Comment: (1) One major drawback of this paper is the lack of velocity data in studying stratification/mixing processes. The authors say that they have compensated this with PEA calculation. But a quantitative explanation is needed.

Figure 9

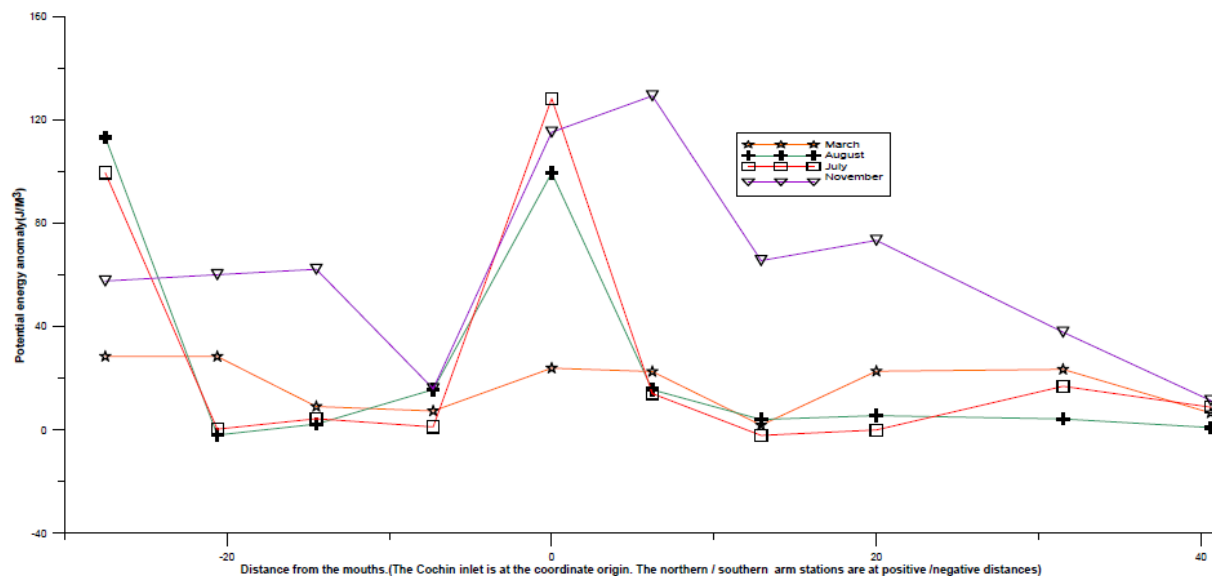
Comment (2) Potential energy anomaly computed for a single fixed station is not going to represent the whole estuary when figures of longitudinal section of salinities depict large spatial variations in stratification. This has to be explained.

REPLY: In accordance with the reviewer's suggestion, we have computed PEA from the density profiles of spring phase of intrusion survey (**Synoptic observation -section 2.2**) for the months July 2008, August 2008, November 2008 and March 2009 which are shown in (**Figure 9**-Please also note the figures to this comment). These months are characterised by south-west monsoon, north-east monsoon and dry period, respectively. The results obtained were in strong agreement with our longitudinal synoptic observations of salinity which are incorporated in the revised manuscript. The spatial variations in **PEA** plainly depict the changes in stratification due to bathymetry and seasonal river discharge. During July, the **PEA** also reached the maximum value of 128.3 J/M^3 near the inlets whereas all the other stations remained well mixed (**PEA~0**). In August also, similar character was observed with high values of **PEA** 113.2 J/M^3 near the inlets. Then river discharge was reduced to 3.34% in November. This resulted in the longitudinal dispersion of the salinity field and the **PEA** in the upstream of the system increased to 68.2 J/M^3 . Later during the dry period (March), discharge was only 1.4%. Therefore, the tidal actions dominated in the system which subsequently turned to well mixed and the average energy required to mix the water column in the estuary was 33.8 J/M^3 .

The spatial variation in the potential energy anomaly is shown in Fig. 9. The potential energy anomaly (PEA) increases with increasing river discharges, specifically to the inlet regions in the south-west monsoon and north-east monsoon periods.
